Review of Plans: **Amazon Site Plan Amendment, 200 & 400 Oritani Drive, Blauvelt, New York, 10913**

Subject: **Amazon Site Plan Amendment**
200 & 400 Oritani Drive, Blauvelt
65.18/1/1 & 22 and 70.06/1/1.12; LO zoning district

Delivery Station Expansion drawing package as prepared by CESO, last revised 10-17-2023 and narrative and binder as prepared by Cuddy + Feder, dated January 18, 2024.

Subject: **Amazon Site Plan Amendment**
Prepreliminary/Preliminary/Final Site Plan
Amendment and SEQRA Review
200 & 400 Oritani Drive, Blauvelt
65.18/1/1 & 22 and 70.06/1/1.12; LO zoning district

Drawing No. **AS1.14**

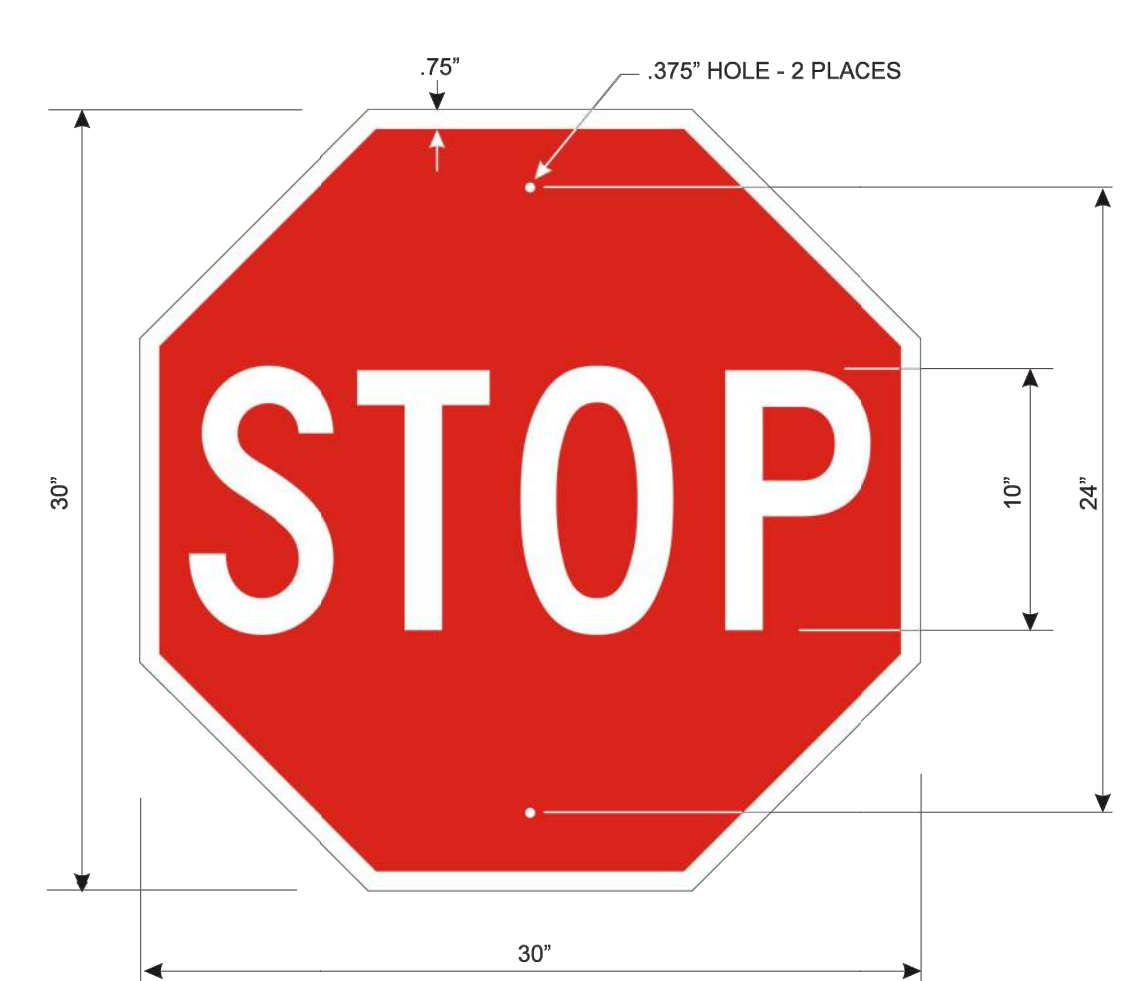
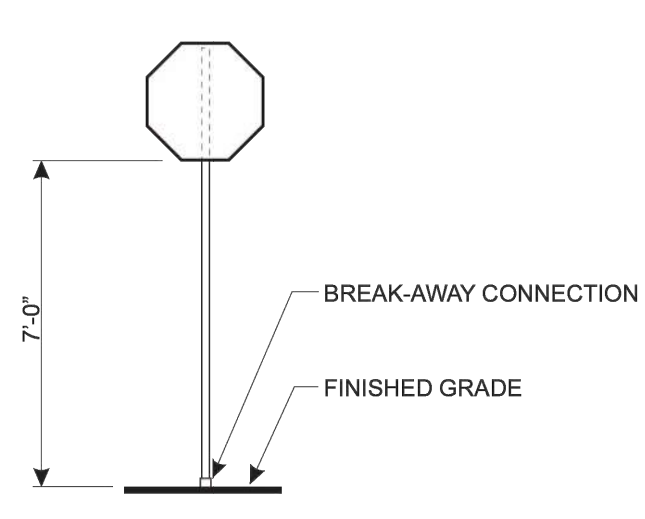
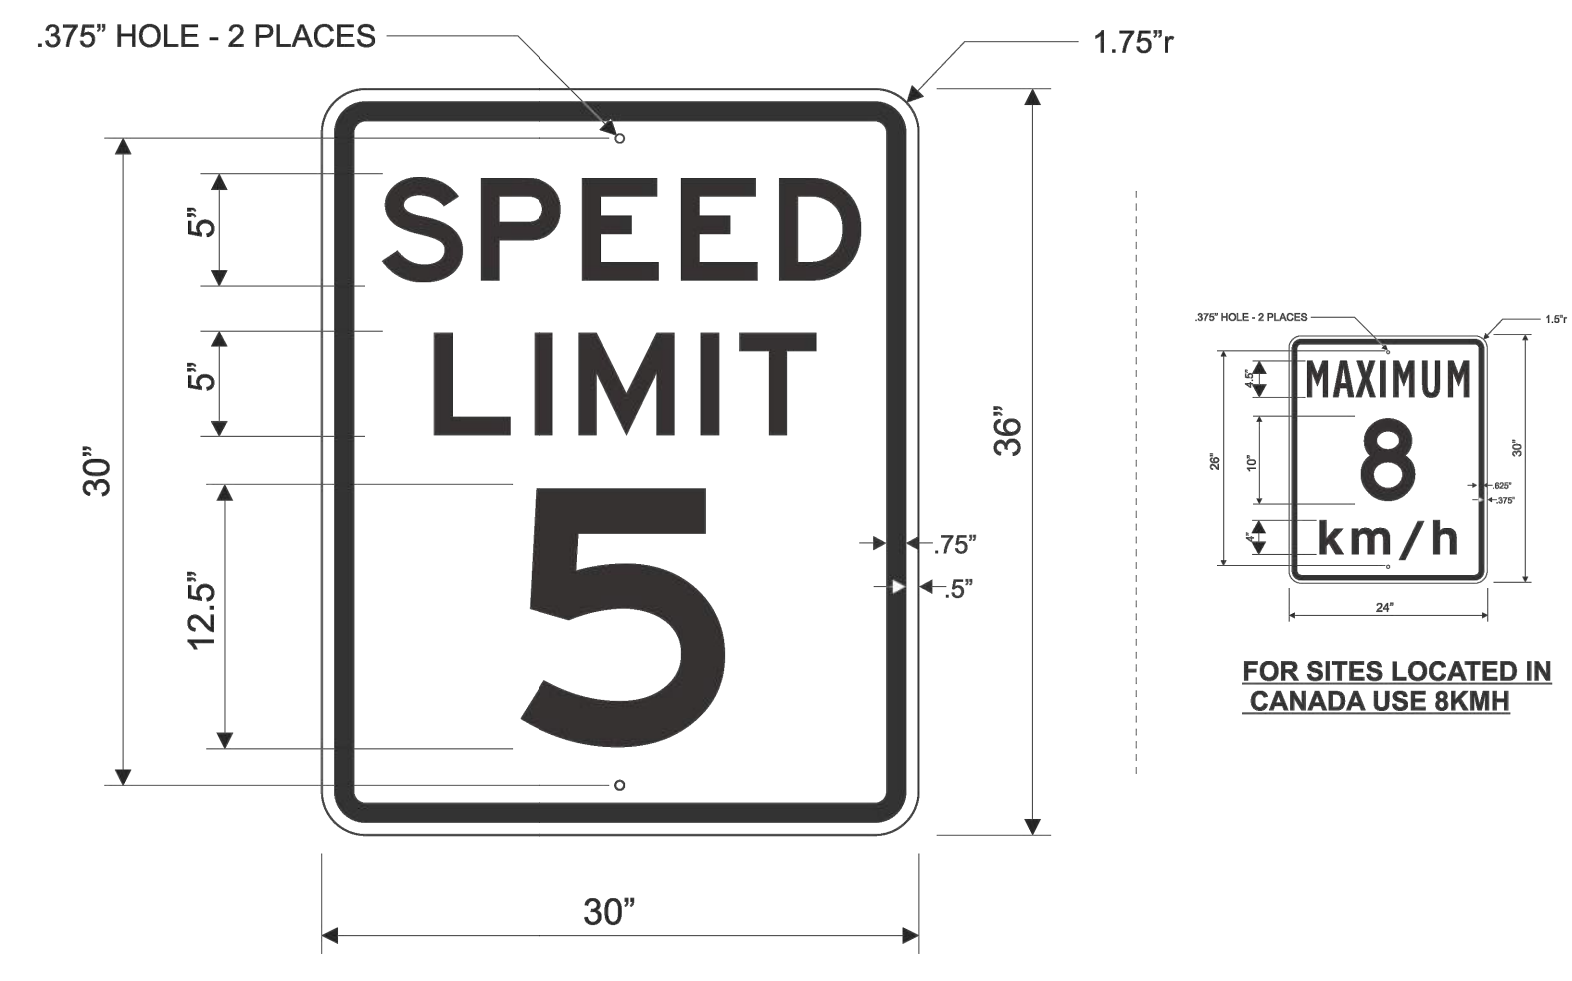
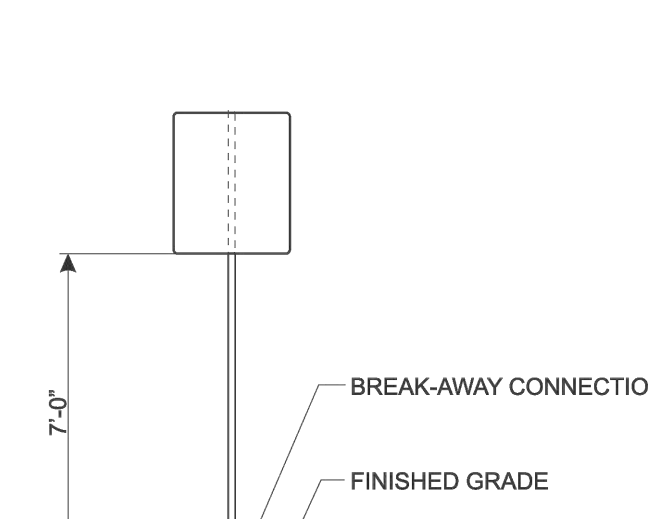
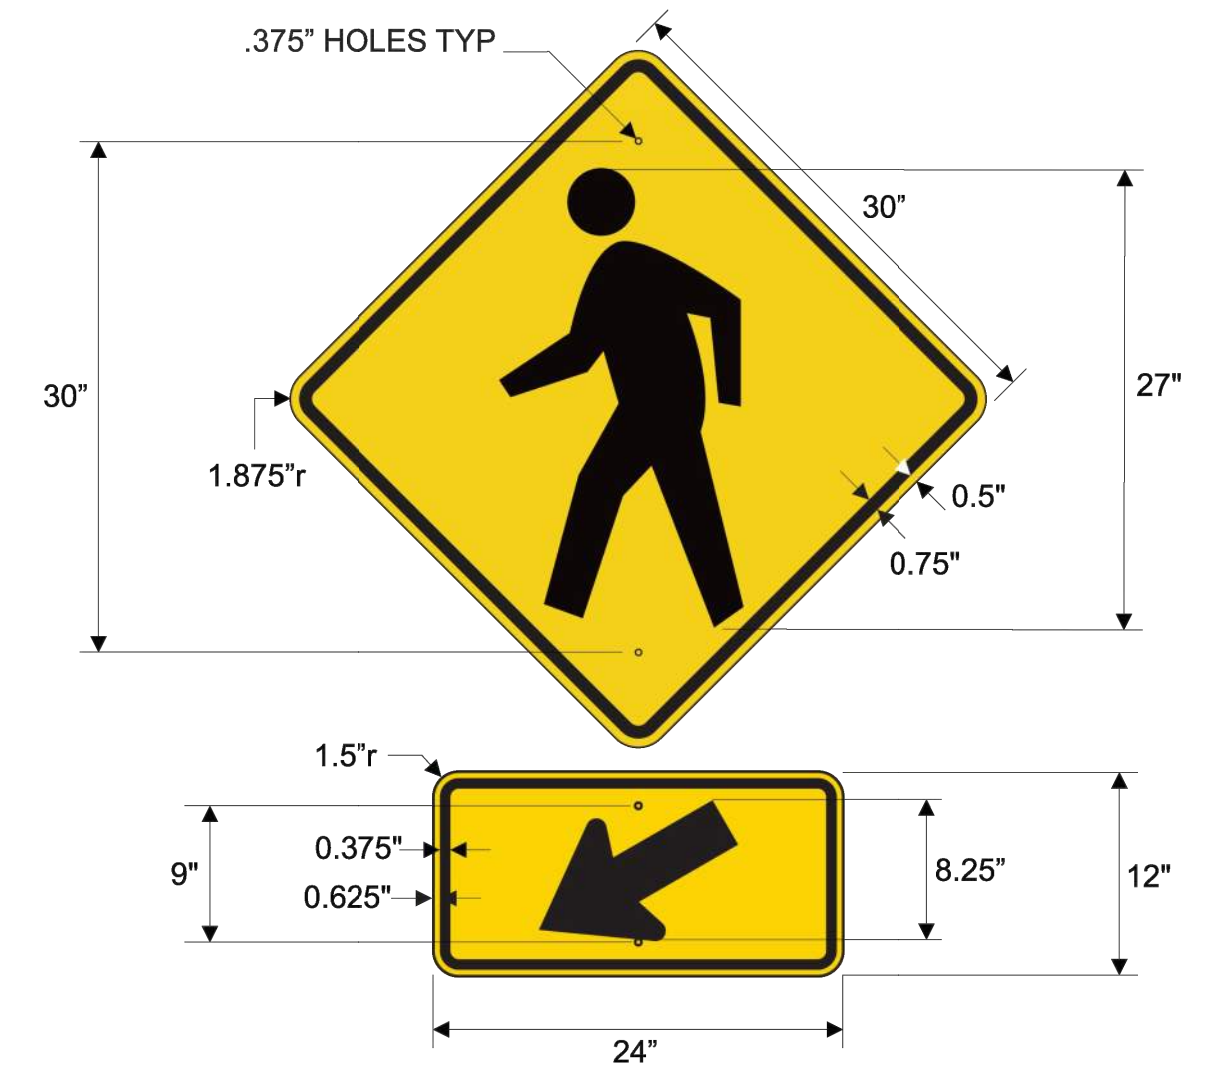
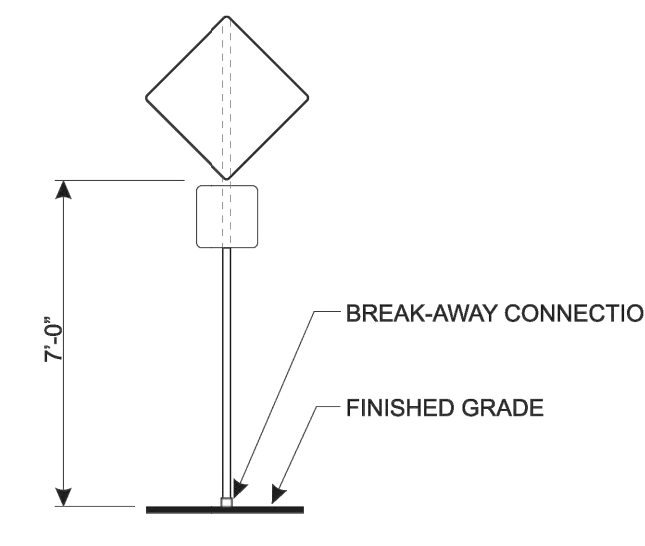
- 6) No details are provided for S-1, S-3, S-5 AND AS-14. Details must be provided in order to determine the effect on the OVERALL signage square footage for the site.
- 7) ACABOR review is required.
- 8) The property lines shall be clearly labeled on the photometric site plan
- 9) The applicant is reminded that no work can begin and no permit will be issued until all comments are met from the various agencies, all approvals are obtained, the Final Site Plan is stamped and the construction plans are reviewed and approved by the inspector.
